©Kawasaki Motors Corp 1974 Printed in USA

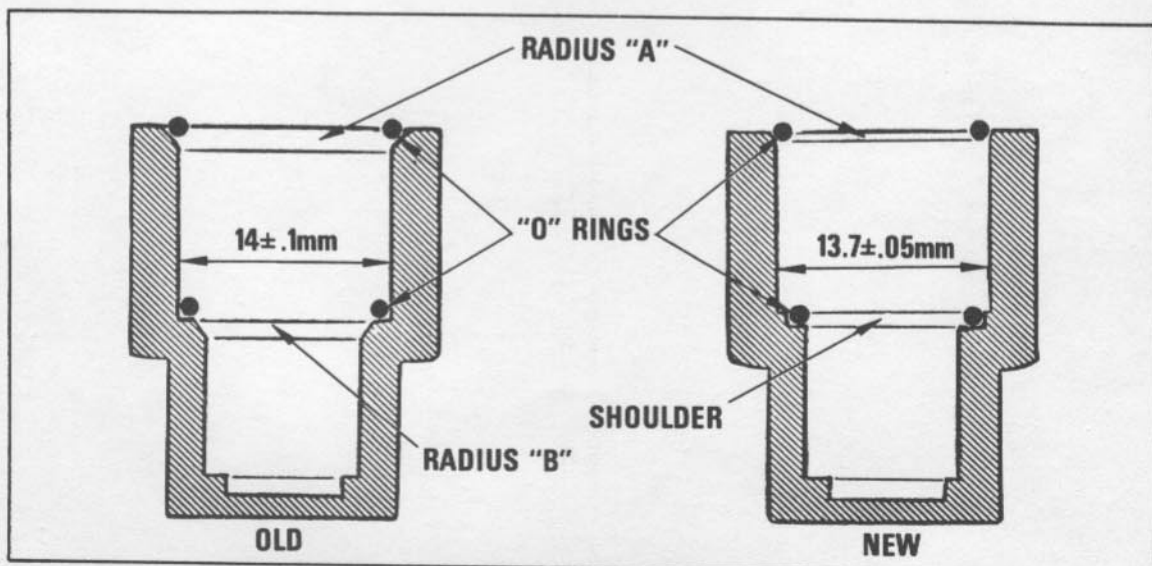
This problem has been traced to faulty O-ring seating in the oil pump end cover. After installation, the two O-rings inside the cover shrink approximately .1 to .2mm in diameter. This shrinkage allows oil to seep around the seals and into the end cover chamber. From this point, the excess oil is pumped to the right cylinder, which is serviced by the end cover orifice, resulting in smoking and premature spark plug failure.

NOTE: *On some very early S2's the end cover chamber was connected to the center cylinder, rather than the right. On all later models ('72, '73) the end chamber is connected to the right cylinder.*

- A. Radius "A" has been decreased in depth to give the O-rings less "squish" space, making a tighter seal.
- B. Radius "B" has been eliminated altogether to improve the seal at that point.
- C. The internal diameter of the chamber has been decreased from $14 \pm .1\text{mm}$ to $13.7 \pm .05\text{mm}$ to compensate for O-ring shrinkage.
- D. A slight shoulder has been added to the base of the new chamber to further compress the O-ring.
